Office Action Summary

10/565,844

DETAILED ACTION

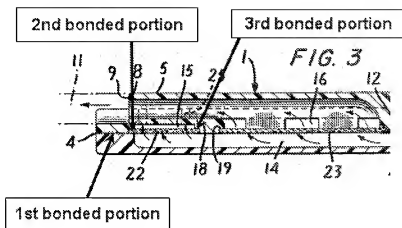
Claim 5, Rosenberg teaches a case with a partitioning member comprising: a case (2), a cover (3) and a partitioning member (22) which is held between the case and the cover partitioning the interior of the case and the cover, characterized in that a second bonded portion (see below) in which the case and the partition member are bonded to each other is provided on the inside of a first bonded portion (see below) in which the case and the cover are bonded together, a third bonded portion (see below) in which the case and the partitioning member are welded to each other is provided on the inside of the second welding portion, and a hole (25) open to the atmosphere is provided in the case between the second bonded portion and the third bonded portion (fig. 3). Rosenberg teaches the partitioning member bonded to the case and the case and cover bonded to one another but does not teach the process of welding. "[E]ven though product-by-process claims are limited by and defined by the process, determination of patentability is based on the product itself. The patentability of a product does not depend on its method of production. If the product in the product-by-process claim is the same as or obvious from a product of the prior art, the claim is unpatentable even though the prior product was made by a different process." In re Thorpe, 227 USDQ 964 (1985). The bonding process of Rosenberg is taken to be a structural alternative to the welding process disclosed herein.
